Intel[®] Pentium[®] III Processor Specification Update

Release Date: August 2001

Order Number: 244453-033

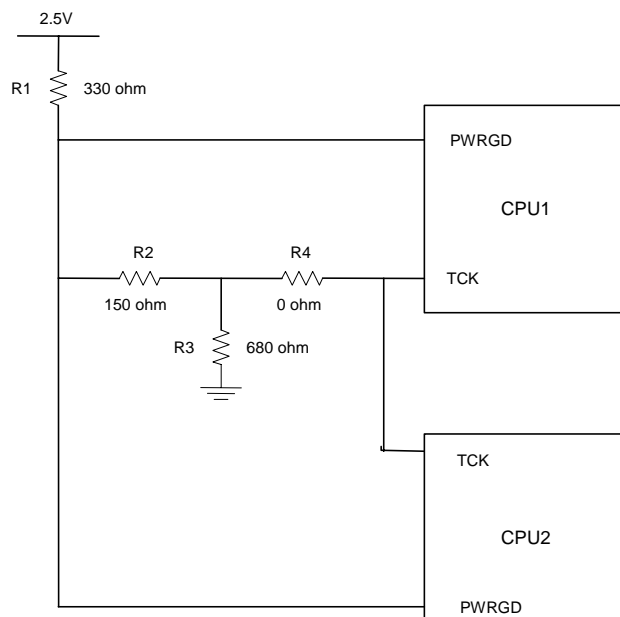
Problem: The internal control register bit responsible for operation of the Thermtrip circuit functionality may power up in a non-initialized state. As a result, THERMTRIP# may be incorrectly asserted during de-assertion of RESET# at nominal operating temperatures. When THERMTRIP# is asserted as a result of this erratum, the processor may shut down internally and stop execution but in few cases continue to execute.

Implication: This issue can lead to intermittent system power-on boot failures. The occurrence and repeatability of failures is system dependent, however all systems and processors are susceptible to failure. In addition, the processor may fail to stop execution during the event of a valid THERMTRIP# assertion resulting in the potential for permanent processor damage.

Workaround: To prevent the risk of power-on boot failures or catastrophic thermal failures, a platform workaround is required. The system must provide a rising edge on the TCK signal during the power-on sequence that meets all of the following requirements:

- Rising edge occurs after Vcc_core is valid and stable
- Rising edge occurs before or at the de-assertion of RESET#
- Rising edge occurs after all Vref input signals are at valid voltage levels
- TCK input meets the Vih min and max spec as mentioned in EMTS
